TITLE : AIR CONDITIONING - GENERAL - FLOW CONTROL AND INDICATING - REMOVE A
PRESSURE SENSE LINE FOR FLOW CONTROL VALVE

MODIFICATION No. : 31332K7283

This page transmits Revision No. 02 of Service Bulletin No. A320-21-1131.

SERVICE BULLETIN No. : A320-21-1131

Figure 1 Sheet 1
Removal of Pressure Sense Line

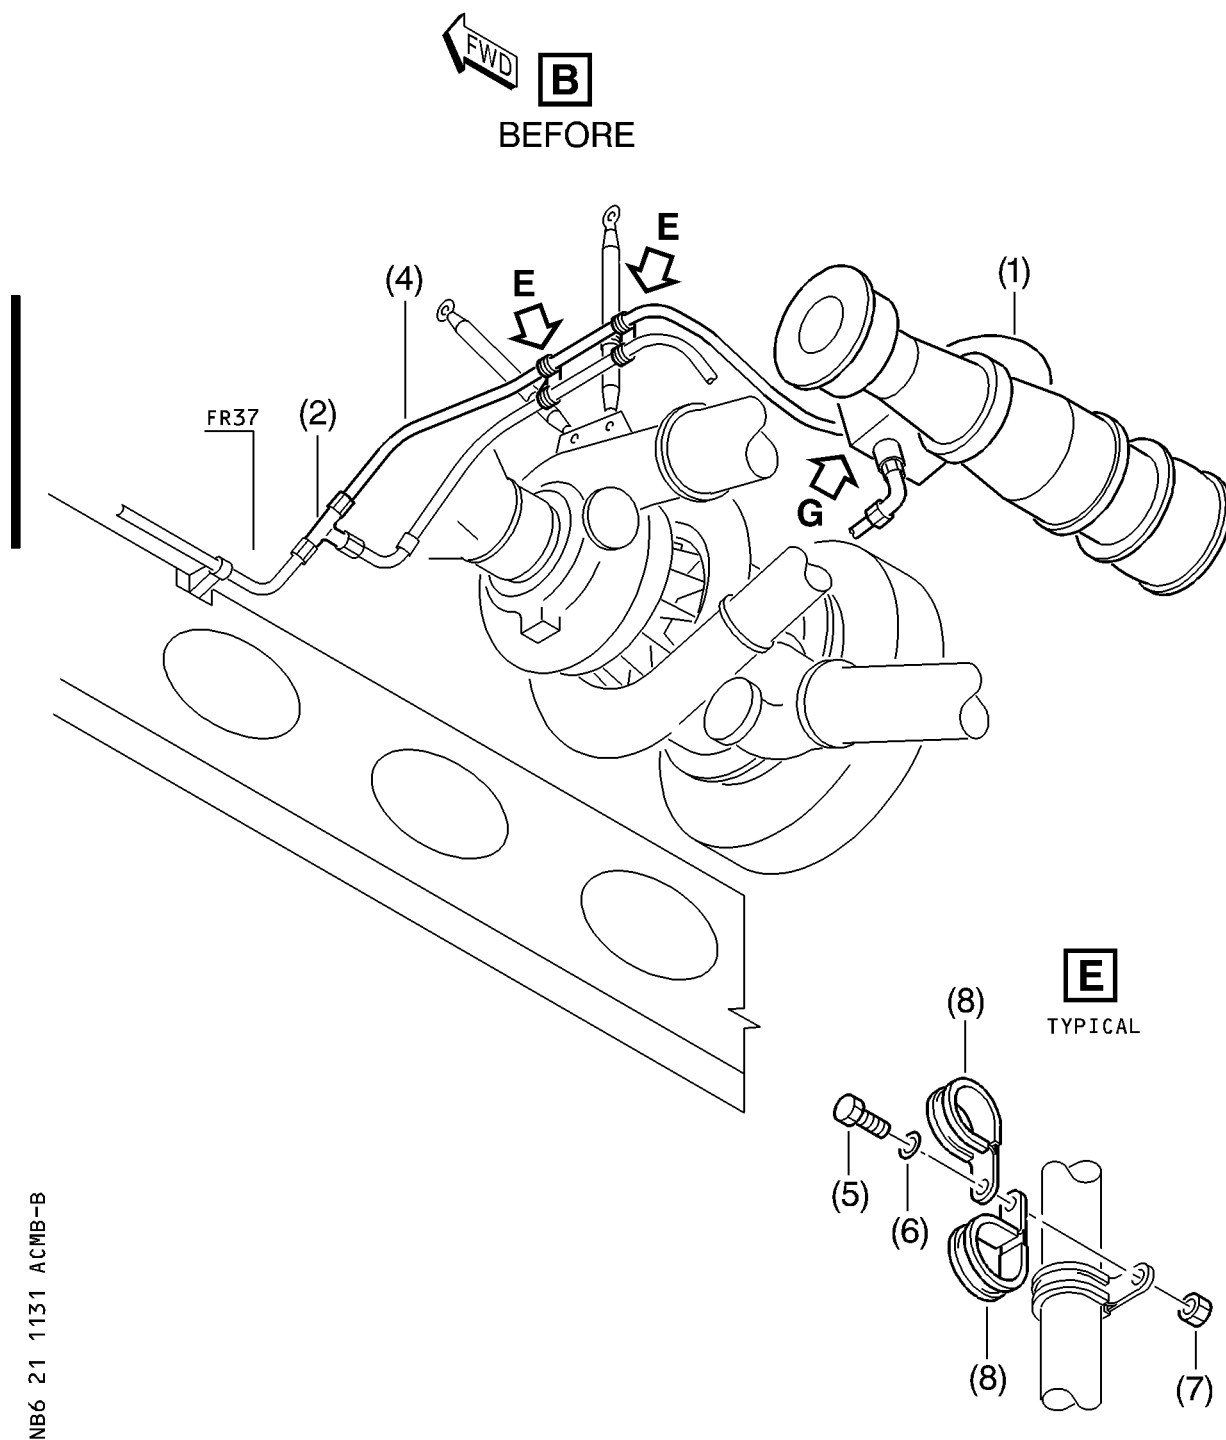
- (a) Remove these items from the flow control valve LH, item (1) and the tee, item (2), as shown in Sheet 1 , Detail A, Sheet 2 , Sheet 3 , Details B and E, Sheet 6 , Sheet 7 , Detail G :

(c) Remove these items from the flow control valve RH, item (1) and the tee, item (2), as shown in Sheet 1 , Detail A, Sheet 4 , Sheet 5 Details C and F, Sheet 6 , Sheet 7 , Detail G :

(a) Install at the tees LH and RH, item (2), these items, as shown in Sheet 1 , Details B and C, refer to AMM 20-21-12 Page block 201:

Figure 1 Sheet 2
Removal of Pressure Sense Line

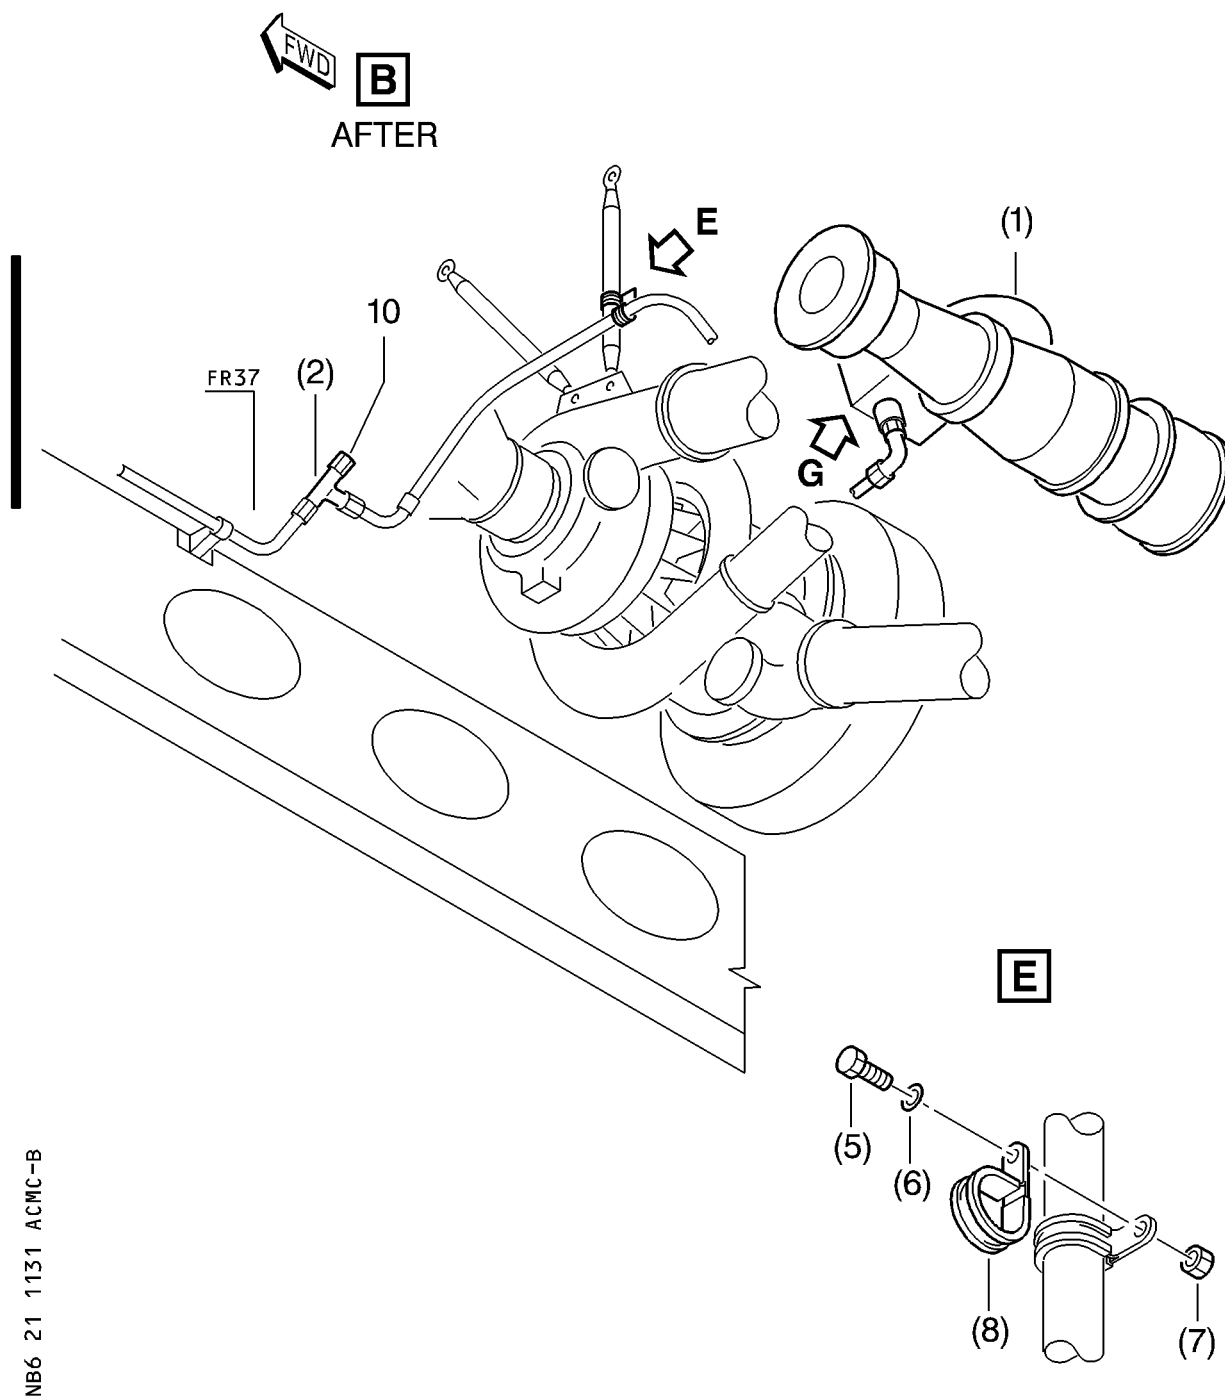
Figure 1 Sheet 2, Detail G added.

Figure 1 Sheet 3
Removal of Pressure Sense Line

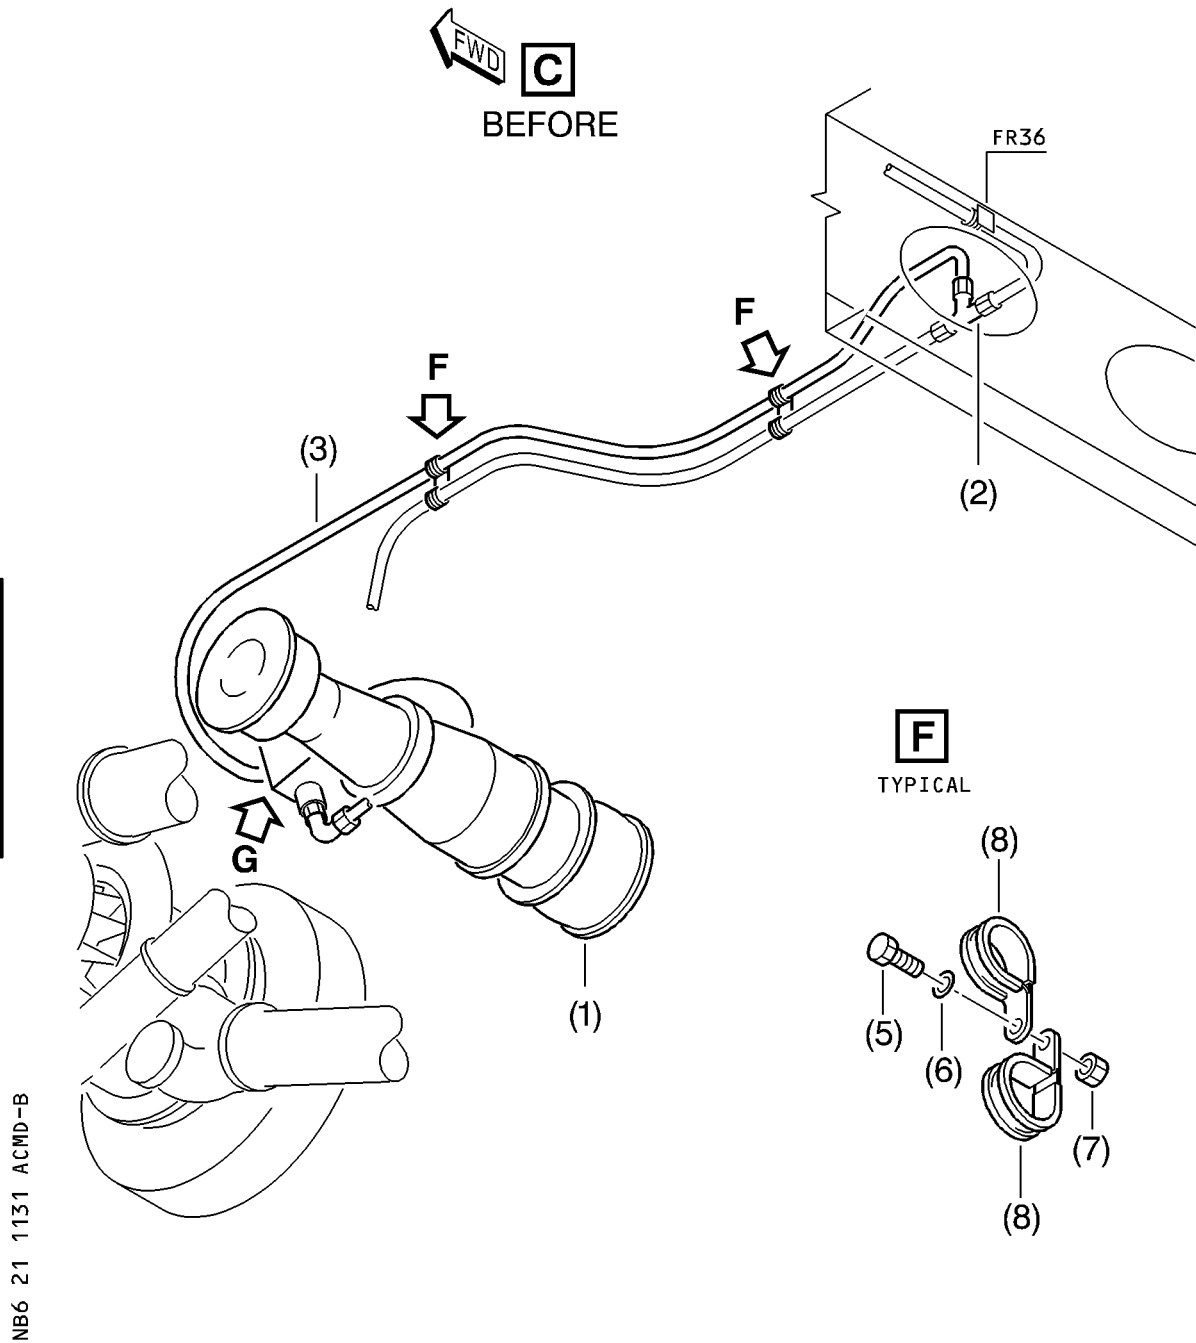
Figure 1 Sheet 3, Detail G added.

(b) Install these items, as shown in Sheet 3 , Detail E :

Figure 1 Sheet 4
Removal of Pressure Sense Line

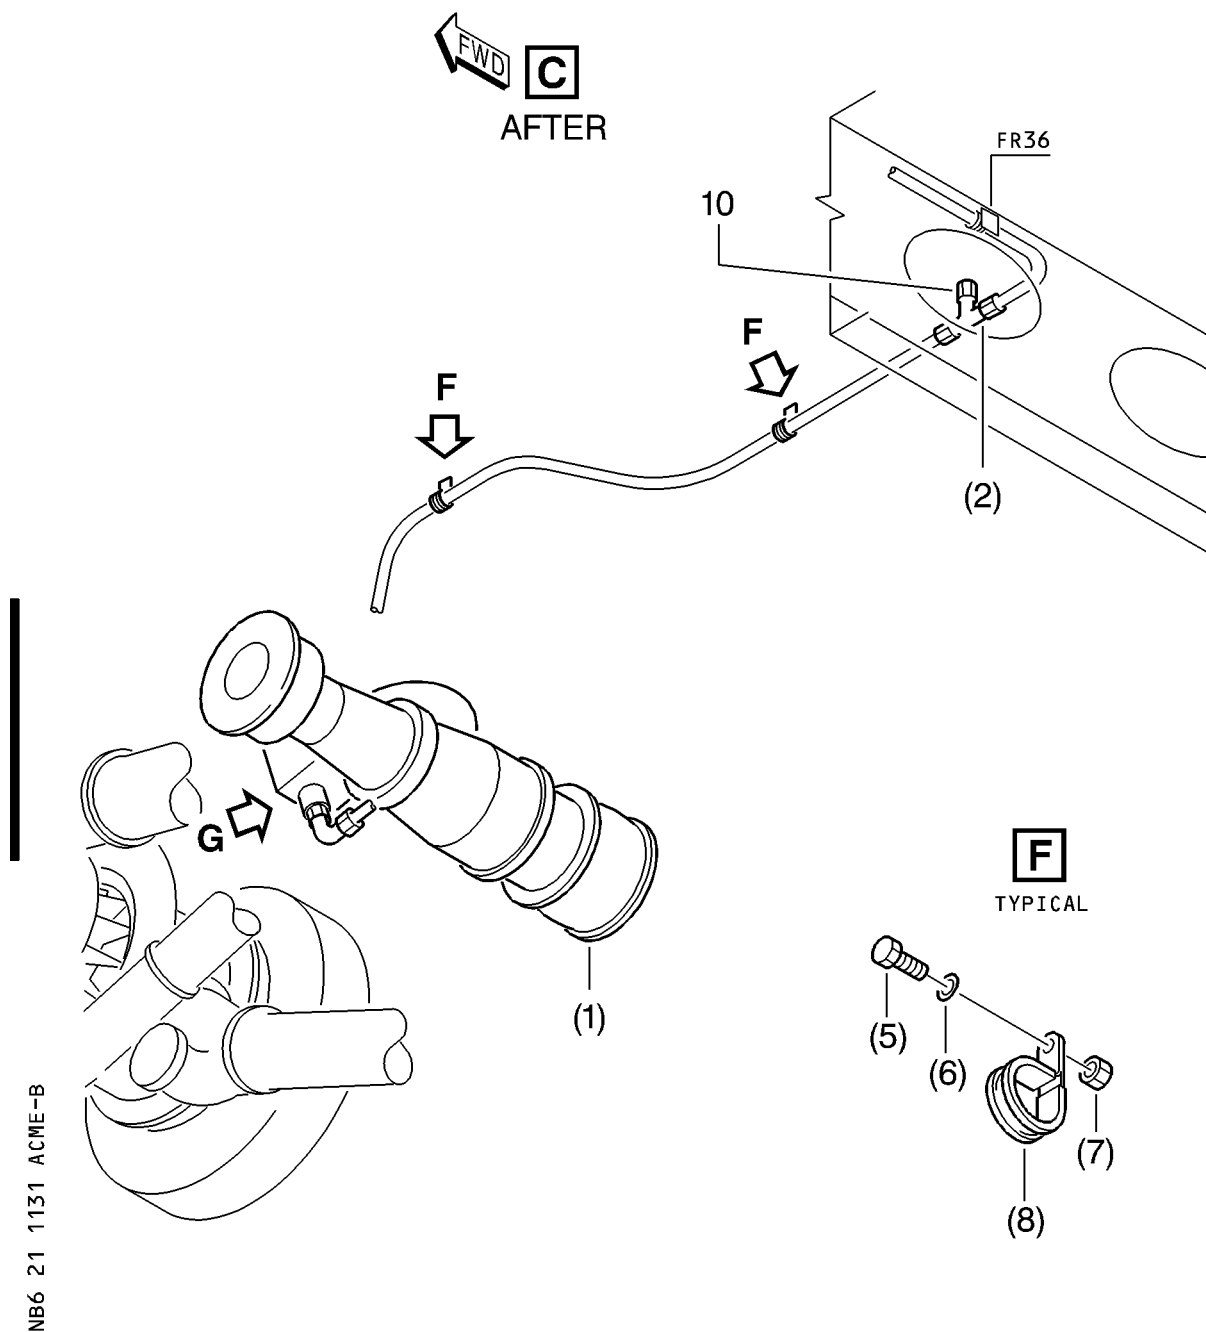
Figure 1 Sheet 4, Detail G added.

Figure 1 Sheet 6
Removal of Pressure Sense Line

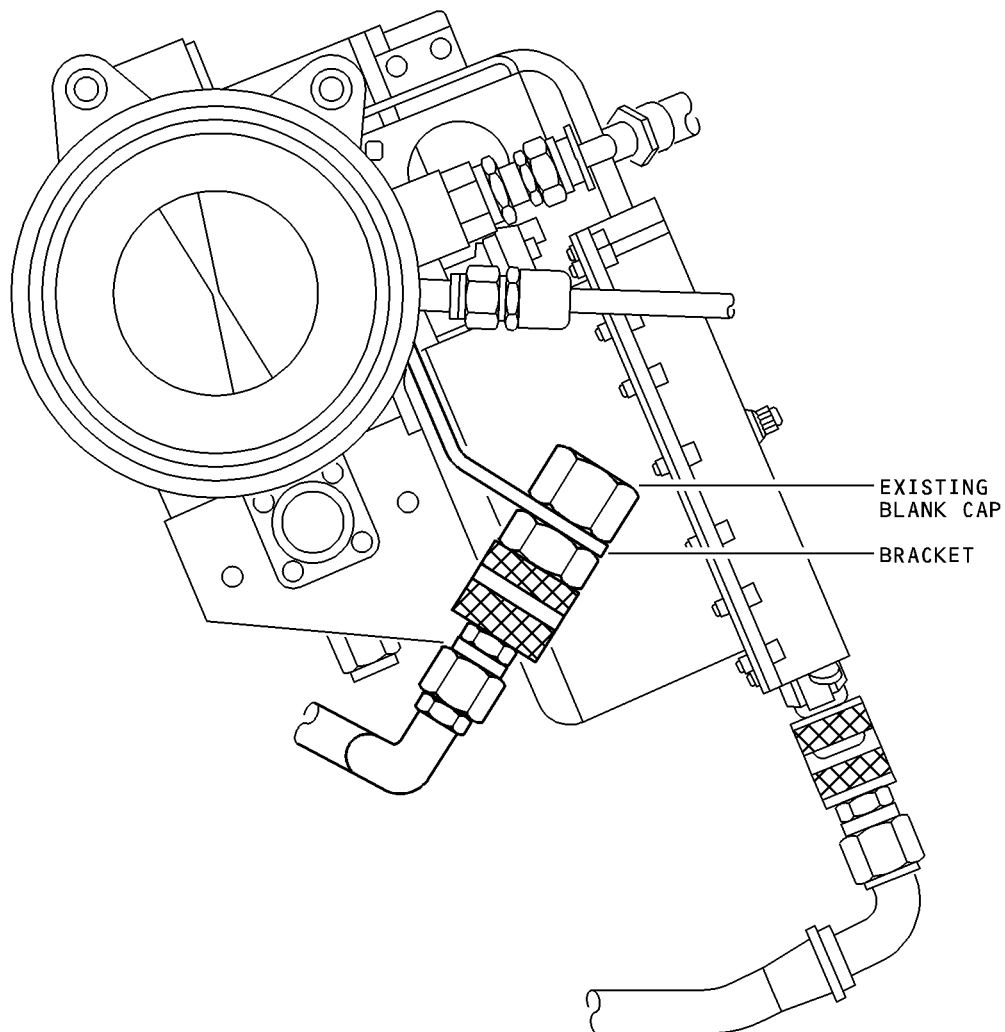
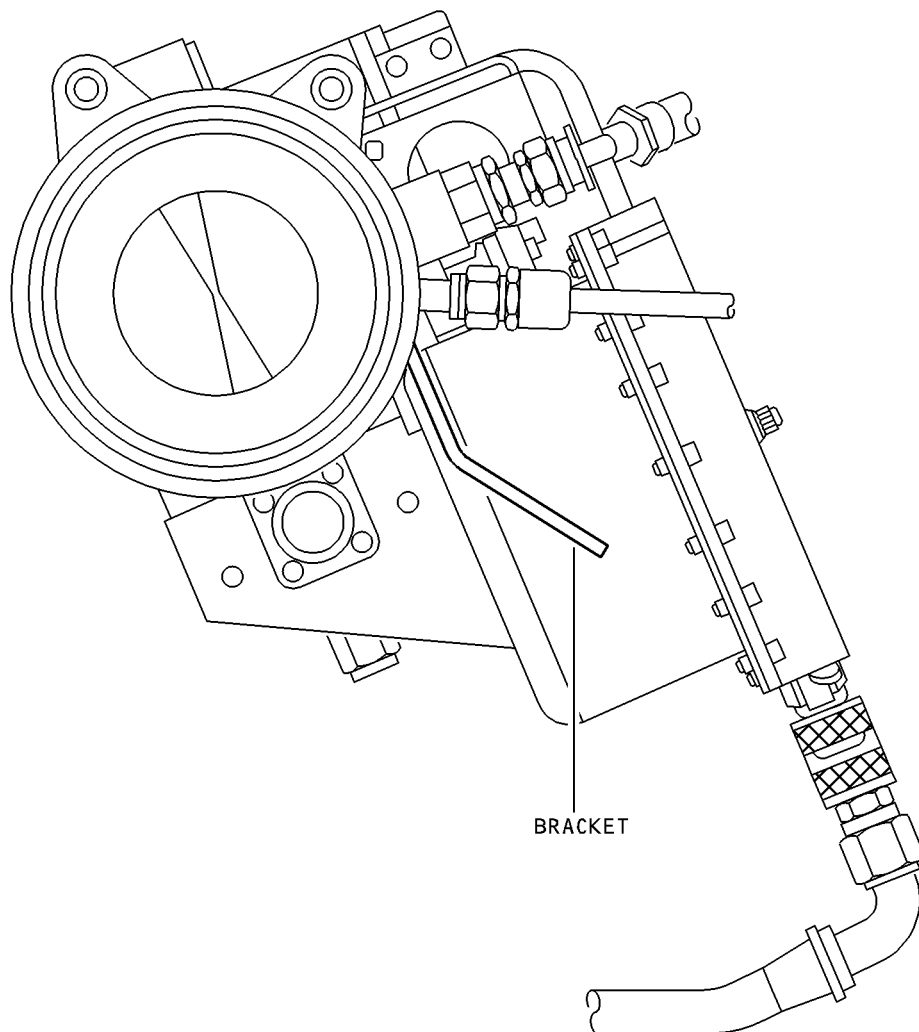
Figure 1 Sheet 6, figure added.

Figure 1 Sheet 7, figure added.
